# UNITED STATES PATENT AND TRADEMARK OFFICE

10/529,154

<b>Office Action Summary</b>	<b>Application No.</b> 10/529,154	<b>Applicant(s)</b> UMENO, YOSHIHISA	
	<b>Examiner</b> Filip Zec	<b>Art Unit</b> 3744

## **DETAILED ACTION**

FIG. A, as annotated by the Examiner: A Cooling Device

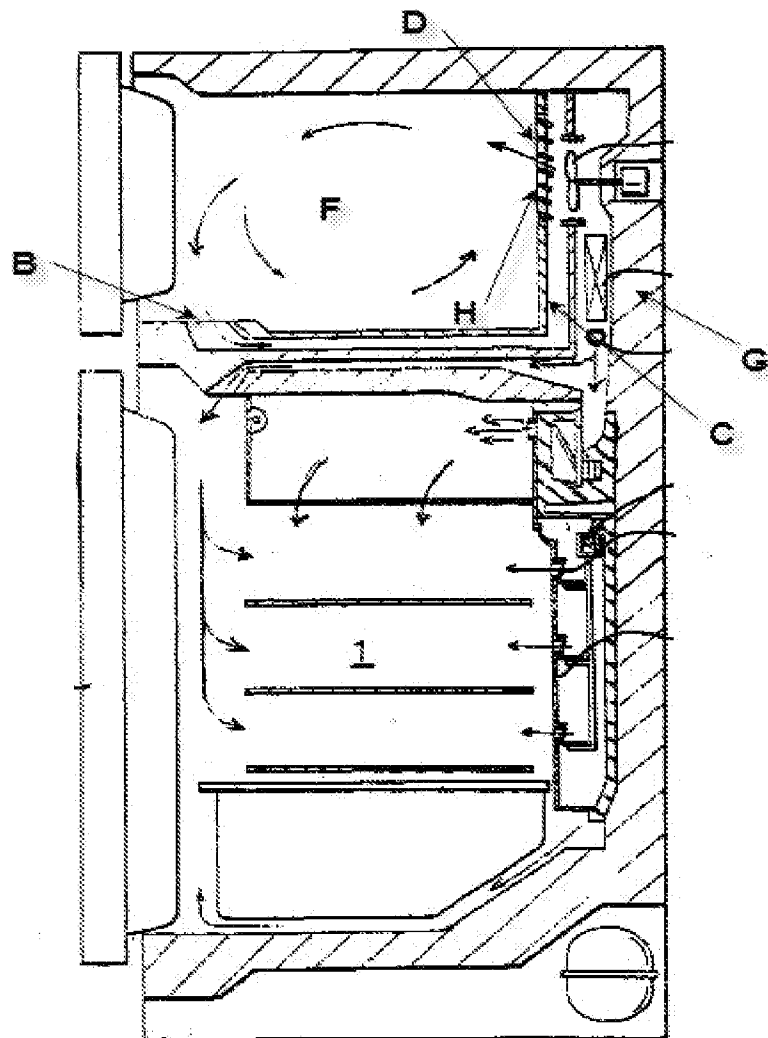
In reference to claim 1, Kim teaches a cooling device (FIG. 2) comprising a cooler (11, FIG. 2) provided on at least one side-wall side (G, FIG. A, as annotated by the Examiner) formed with a thermal insulating box (inherent in a freezer construction as shown in Kim, see FIG. 2); a cooling chamber (F, FIG. A) in front of the cooler (11, FIG. 2); and a fan (20, FIG. 2) that allows air in the cooling chamber to flow, wherein the cooler and the cooling chamber are partitioned by a partition (C, FIG. A) so as to allow cold air to be accumulated in the cooler, the fan (20, FIG. 2) is disposed on a side of the cooler (11, FIG. 2) relative to the partition (C, FIG. A), the partition in front of the fan (20, FIG. 2) has an aperture (D, FIG. A) formed in a flat sheet portion (above and below partition C, FIG. A), an open space is formed between the fan and the flat sheet portion in which the aperture is formed (see FIG. 2), cold air accumulated in a space inside the partition, and hot air in the cooling chamber are exchanged by the fan (20, FIG. 2) through the aperture (D, FIG. A), wherein the rotation of the fan generates a discharged flow of cold air discharged from the cooler to the cooling chamber through the aperture and a sucked flow of cold air sucked from the cooling chamber to the cooler through the aperture, and the discharged flow and the sucked flow directed from the cooling chamber to the cooler collide with each other in a portion in which the aperture is provided (inherent in the structure as described in Kim, see FIG. 2), but does not teach that the perimeter of the fan is not surrounded by a cylindrical component, and the open space is formed outside the fan in the radial direction. Lazar teaches a forced convection evaporator (FIG. 3) wherein a fan (58, FIG. 3) is located inside the casing (2,

In reference to claim 2, Kim, Lazar and Clark disclose the cooling device as explained in the rejection of claim 1, and Kim also teaches that dimensions of the aperture (D, FIG. A) are larger than a diameter of the fan (20, FIG. 2).

direction of a rotation shaft of the fan, the fan is disposed in the aperture (D, FIG. A) and there is an open space outside the fan (in front and around of fan 20, FIG. 2).

In reference to claim 5, Kim, Lazar and Clark disclose the cooling device as explained in the rejection of claim 1, and Kim also teaches that the discharged airflow and the sucked flow collide with each other, thus suppressing the flow speed of the cold air (inherent in the structure as described in Kim, see FIG. 2 and FIG. A).

In reference to claim 8, Kim, Lazar and Clark disclose the cooling device as explained in the rejection of claim 1, and Kim also teaches that a slit (B, FIG. A) is formed in the partition (C, FIG. A) at a portion below the cooler (11, FIG. 2).

In reference to claim 10, Kim, Lazar and Clark disclose the cooling device as explained in the rejection of claim 1, and Kim also teaches that a safety cover (grille H, FIG. A) is disposed over the fan aperture (D, FIG. A).
